Re: **Application for Planning Permit No. 1033/2018**  
Address: **472-474 St Kilda Road, MELBOURNE VIC 3004**

# PLANNING PERMIT

472-474 ST KILDA ROAD, MELBOURNE VIC 3004

Construct a multi-storey mixed use building, comprising a retail, food and drinks premises, bar, serviced apartments and dwellings, a reduction in the number of car parking spaces required and a licence for the sale and consumption of liquor.

Drawing Number:  
**TP-21-12**

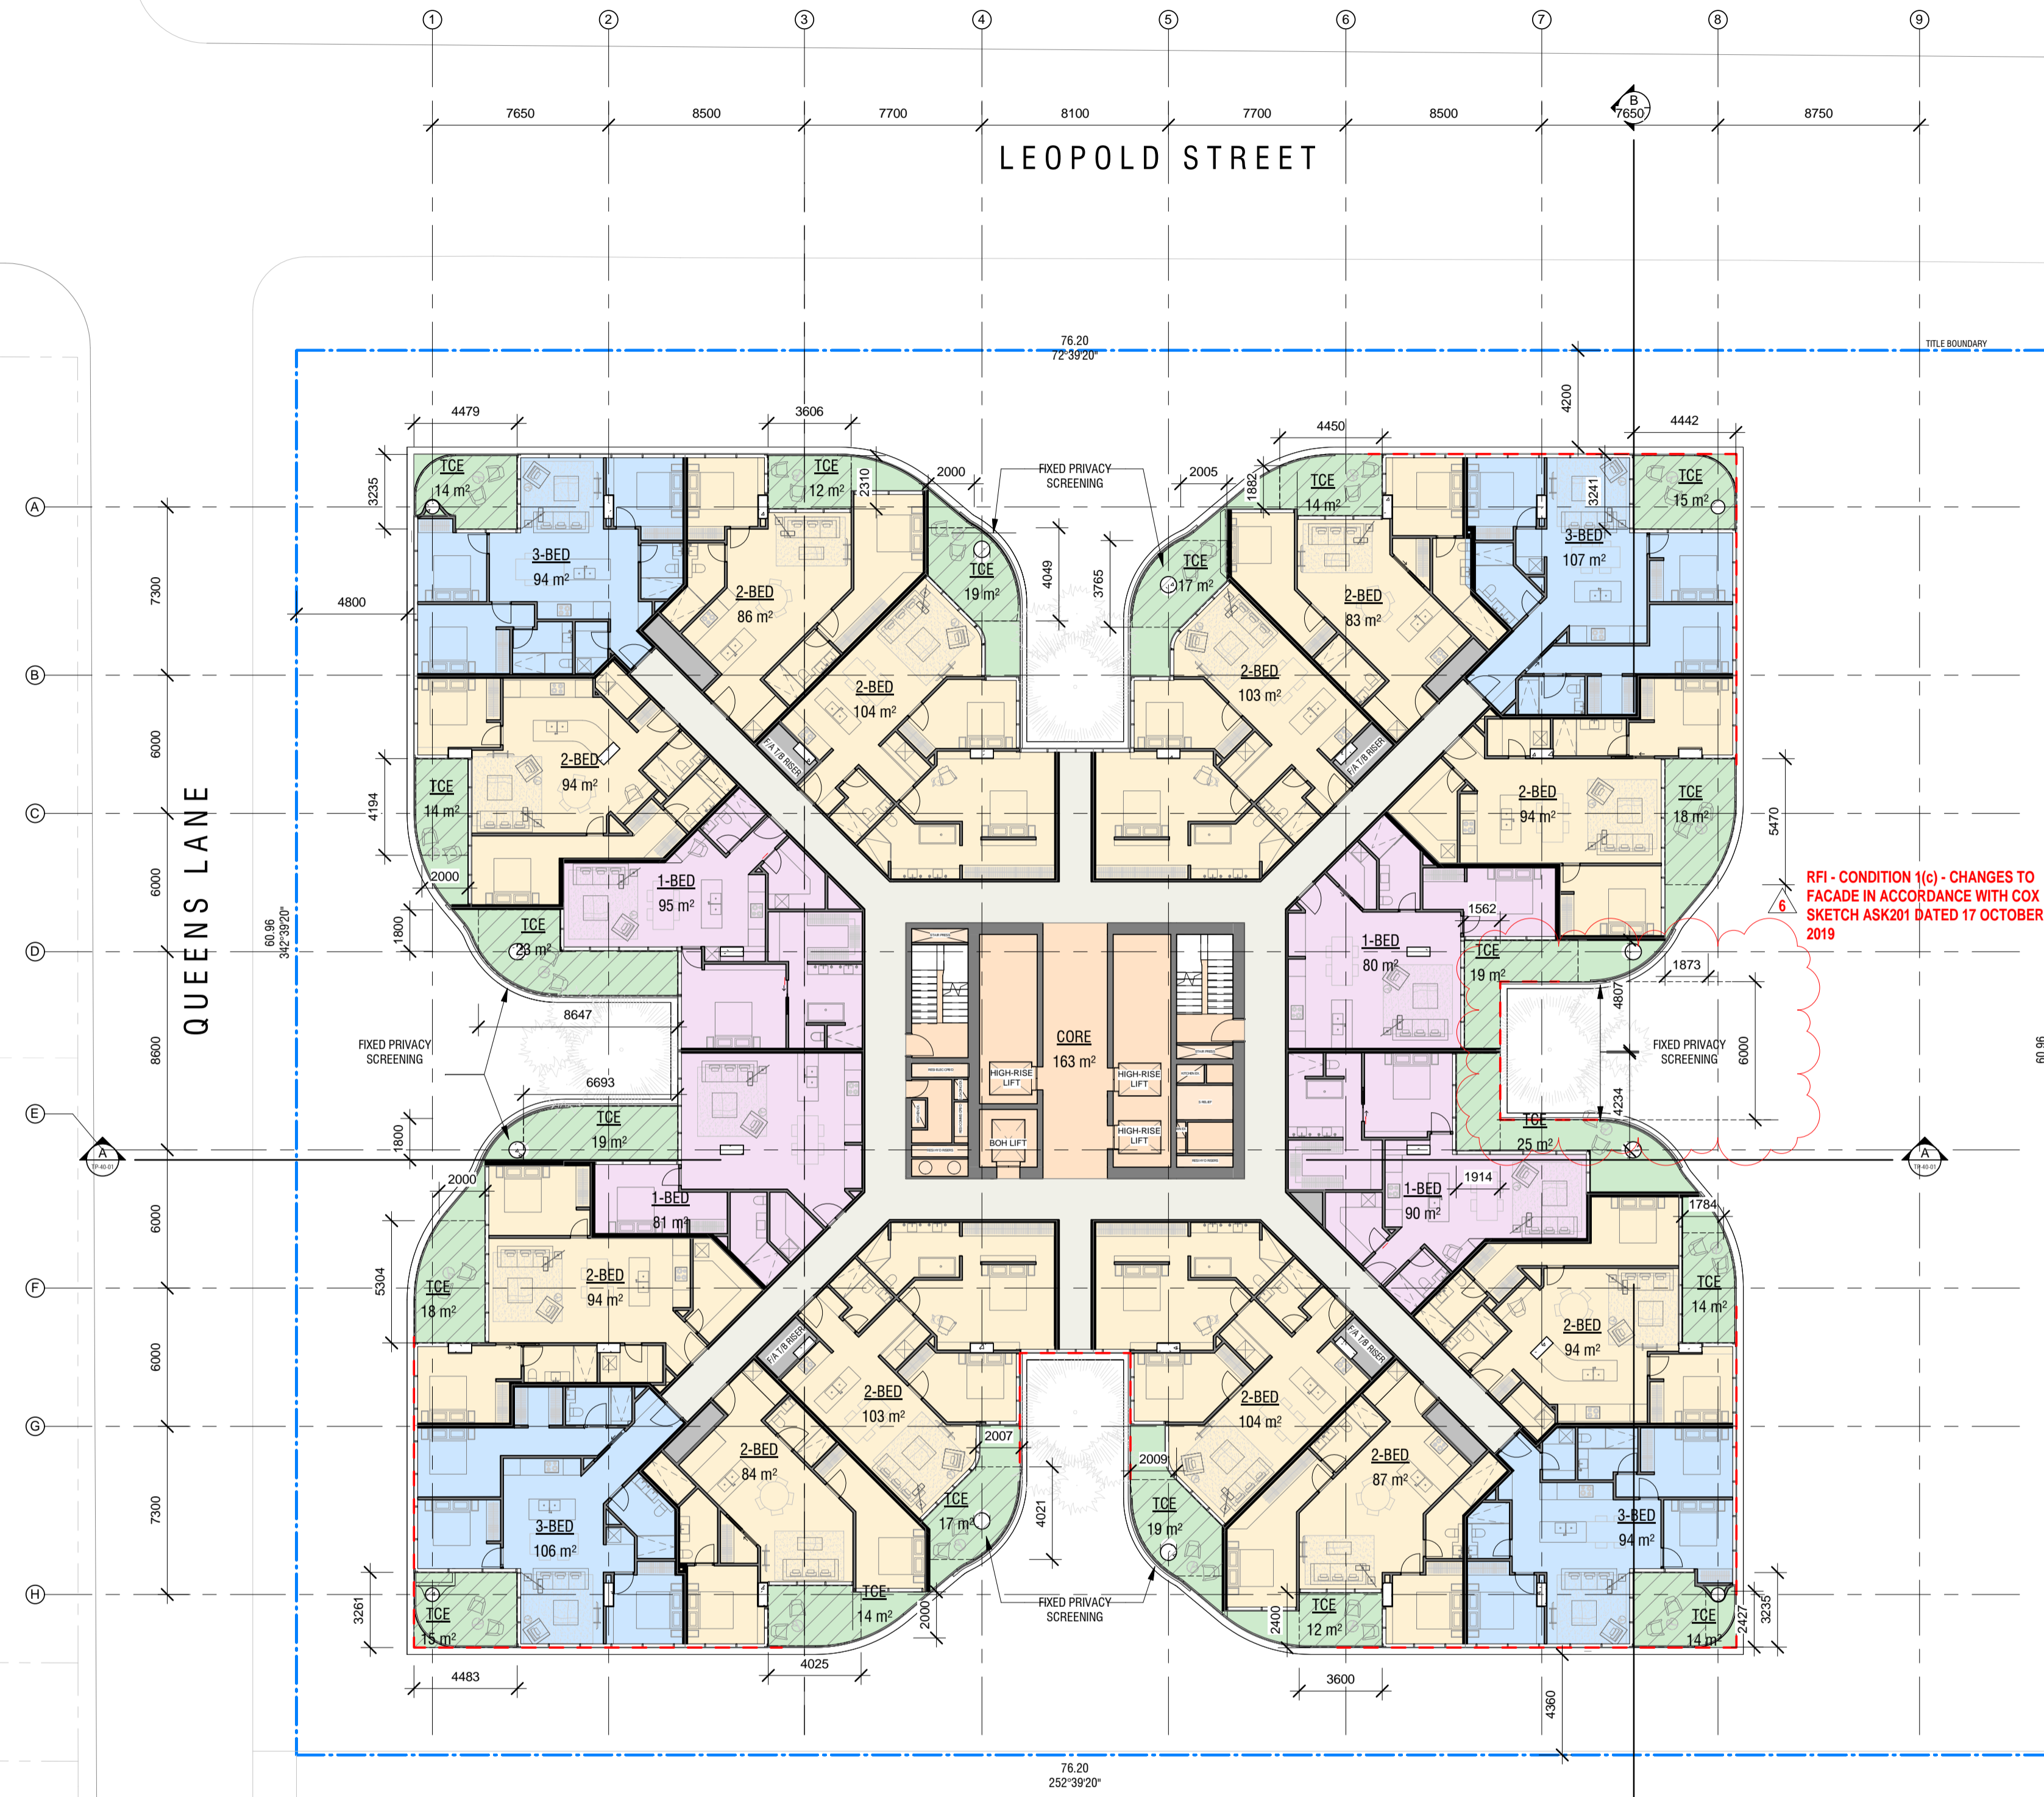
RFI - CONDITION 1(c) - CHANGES TO  
FACADE IN ACCORDANCE WITH COX  
SKETCH ASK201 DATED 17 OCTOBER  
2019

Drawing Number:  
**TP-21-16**

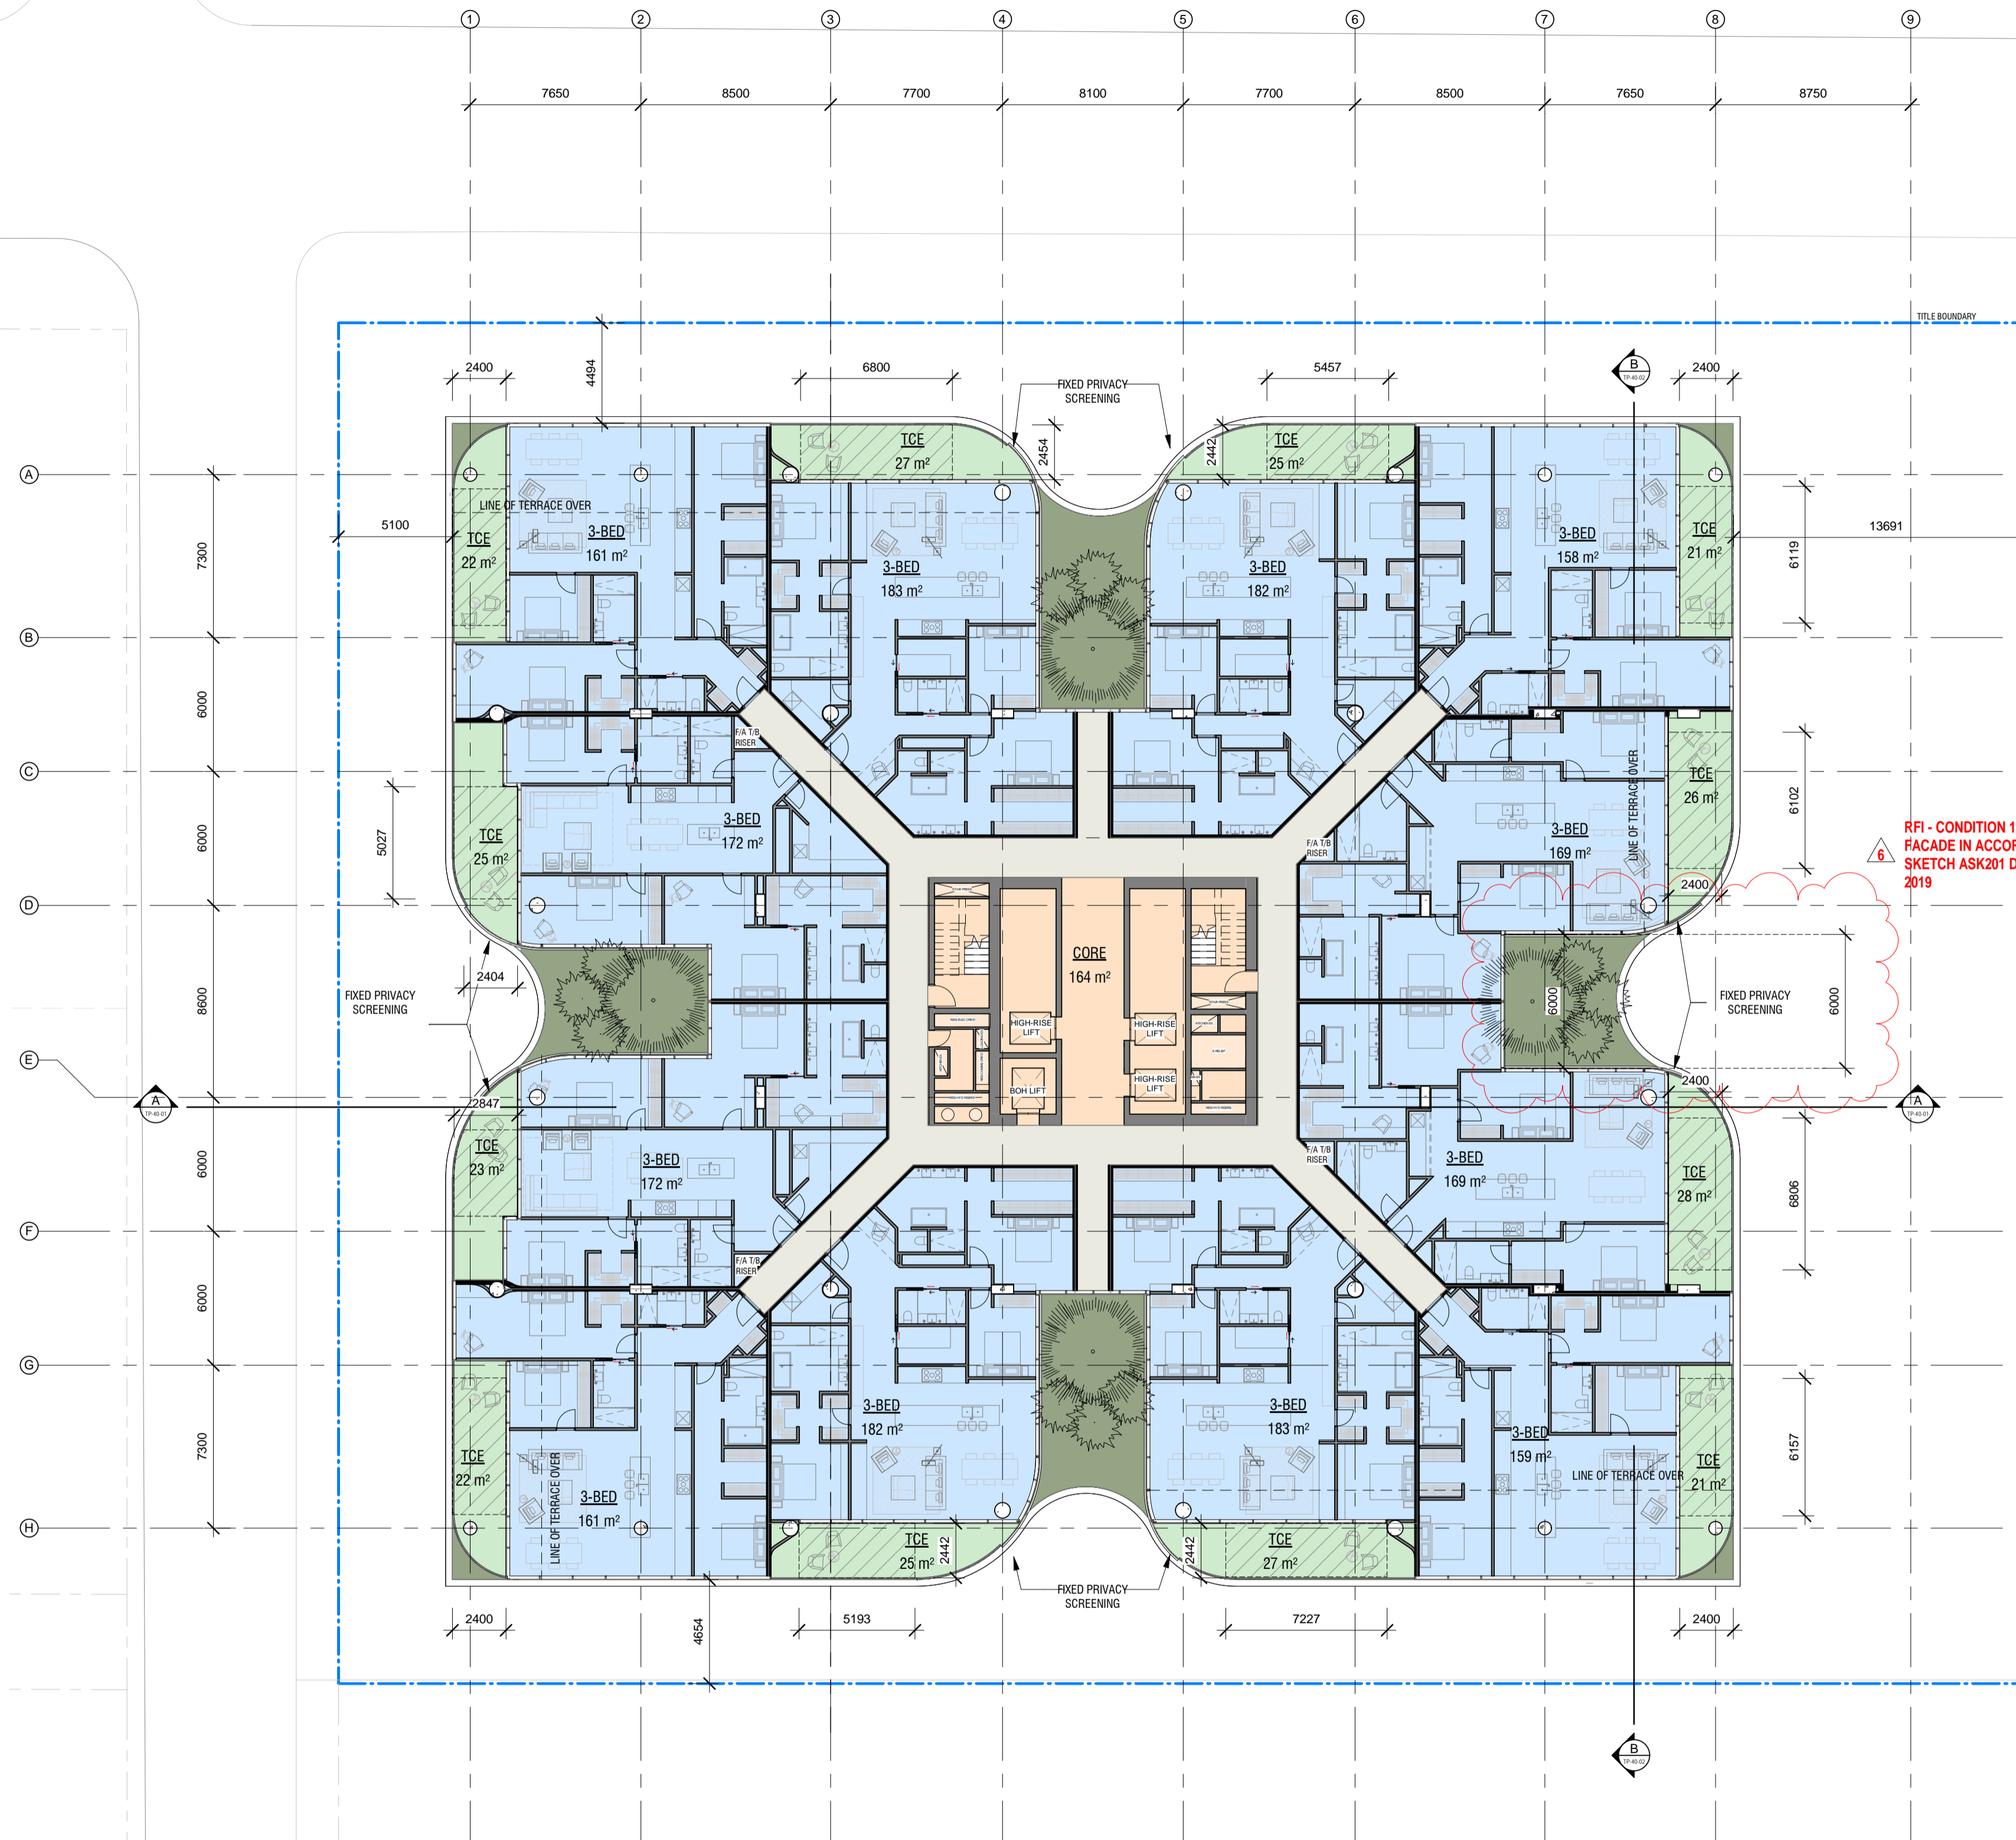
RFI - CONDITION 1(c) - CHANGES TO  
FACADE IN ACCORDANCE WITH COX  
SKETCH ASK201 DATED 17 OCTOBER  
2019

Drawing Number: **TP-30-04**  
 Revision: **6**  
 Date: **03.07.20**

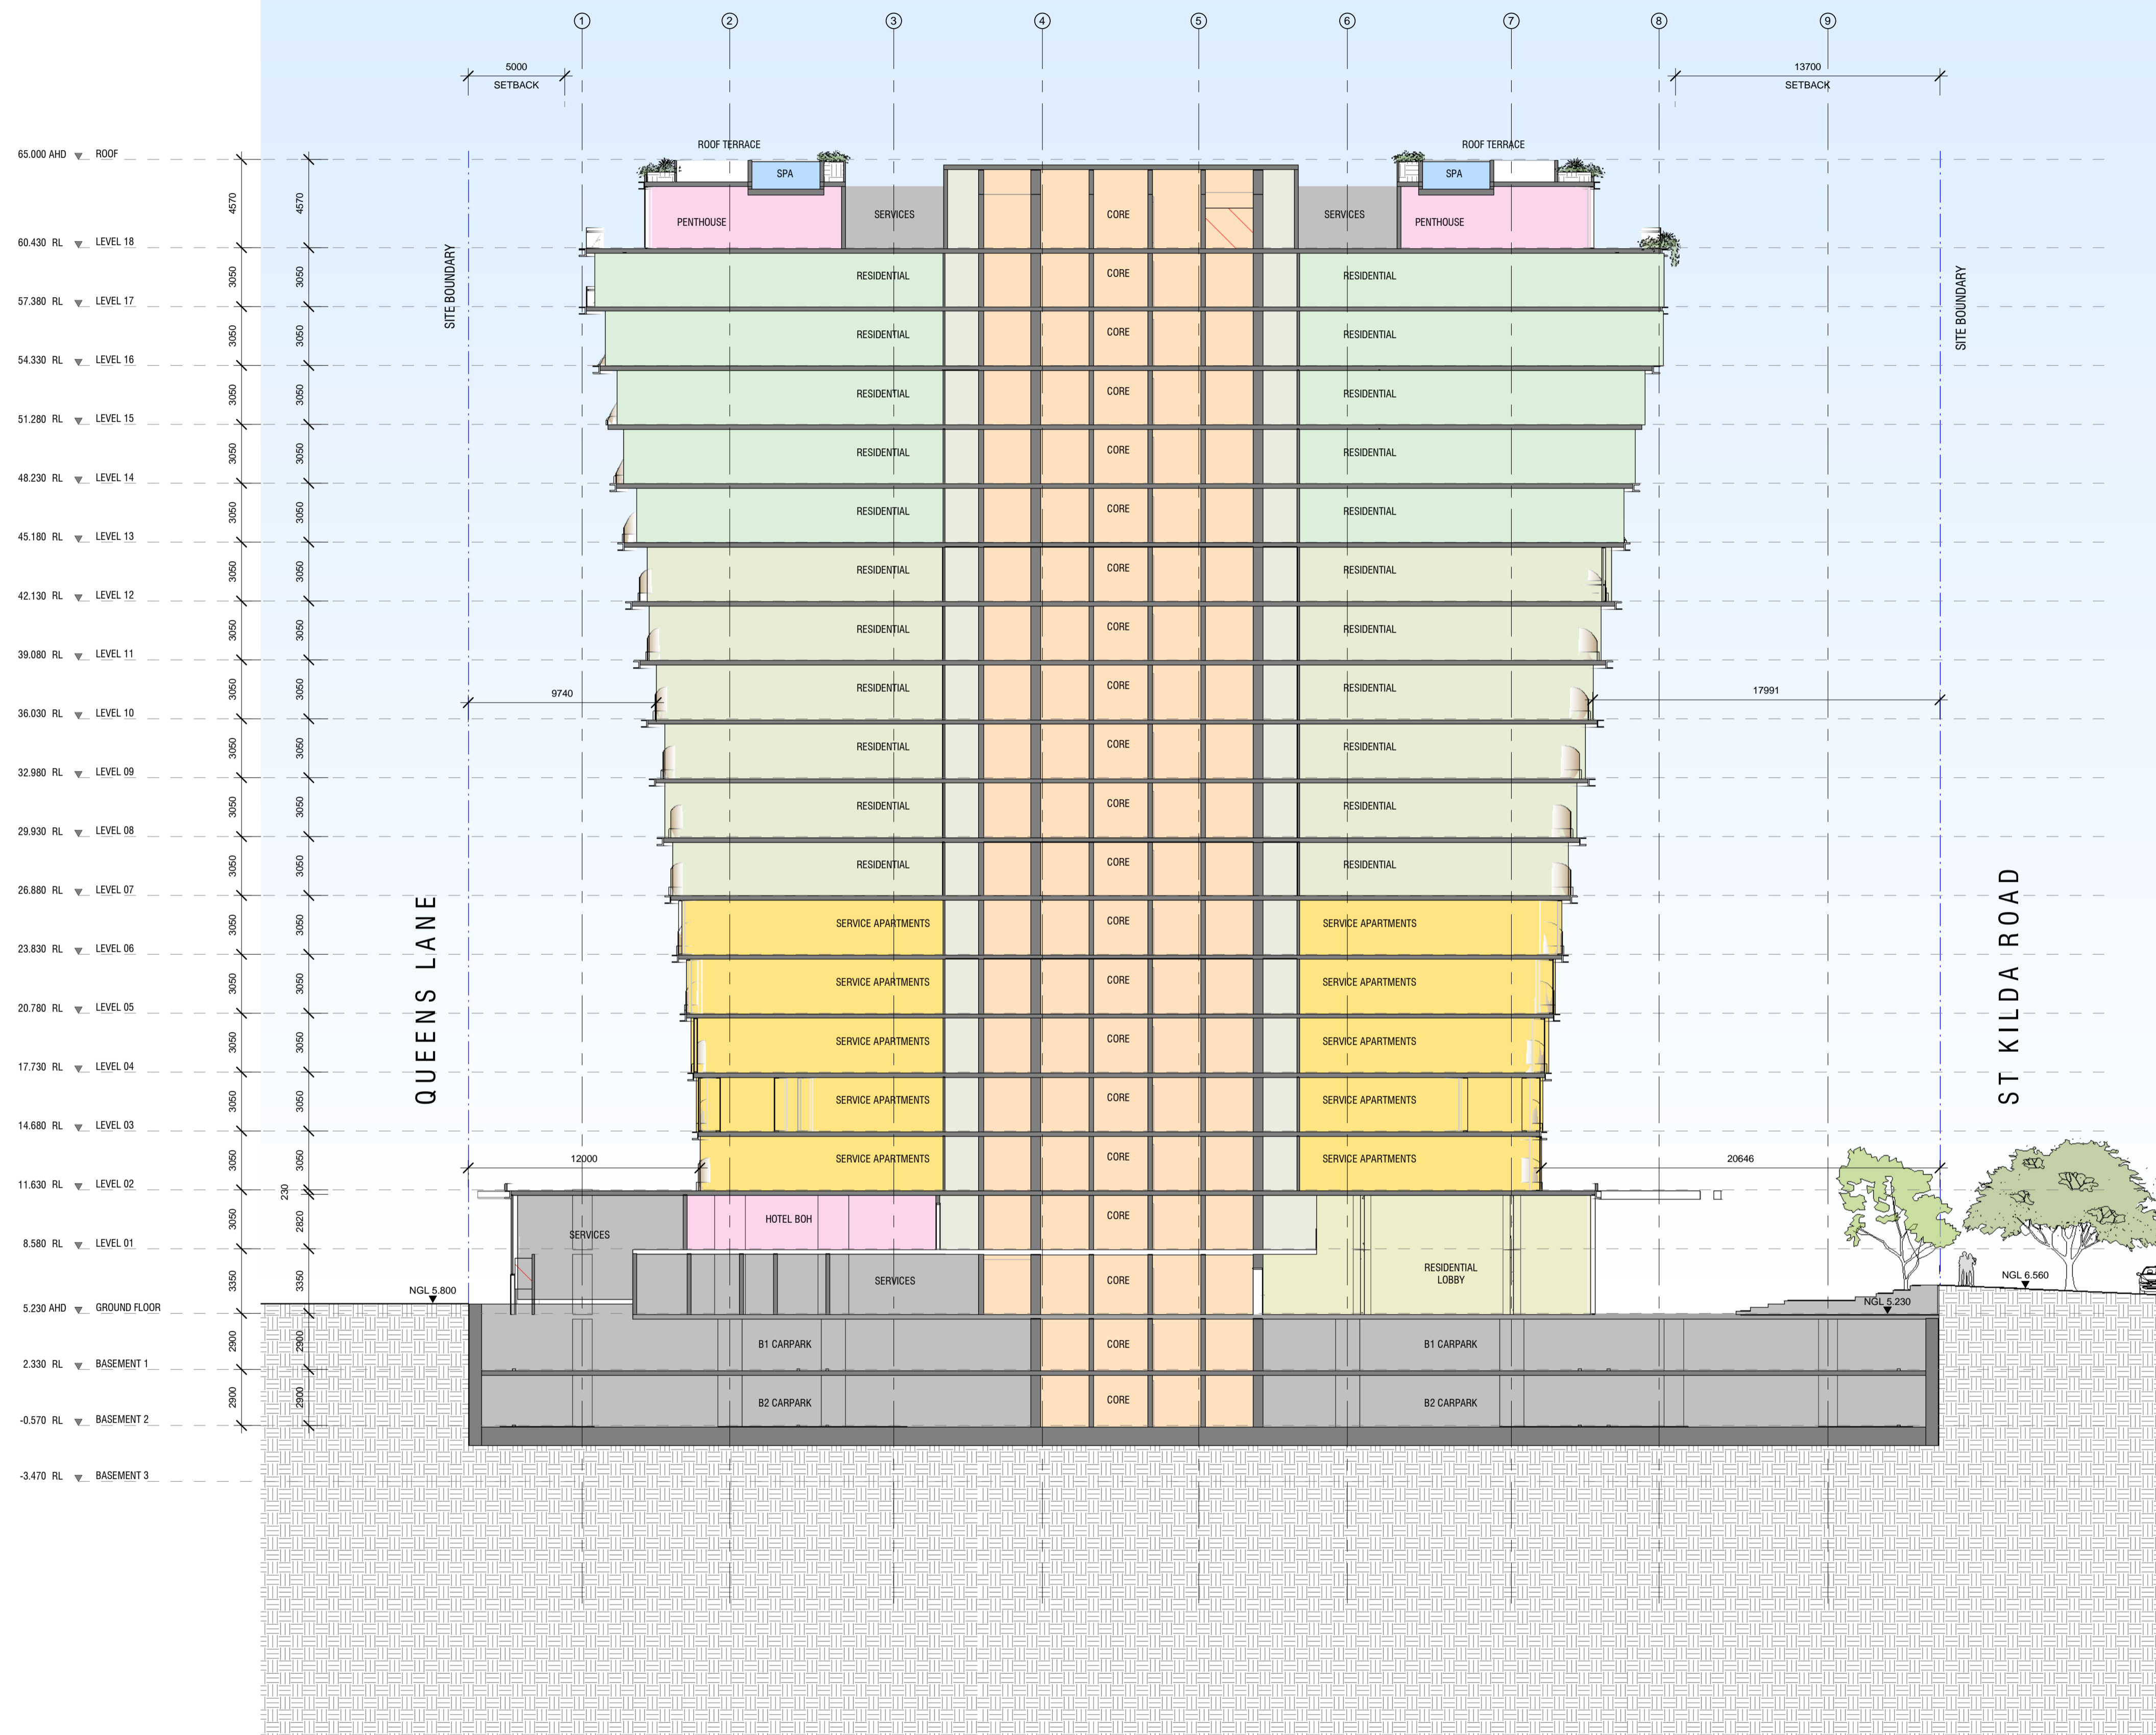
RFI - CONDITION 1(i) - PRIVACY MEASURES TP LIMIT VIEWS FROM WESTERN GLAZING IN THE GYM
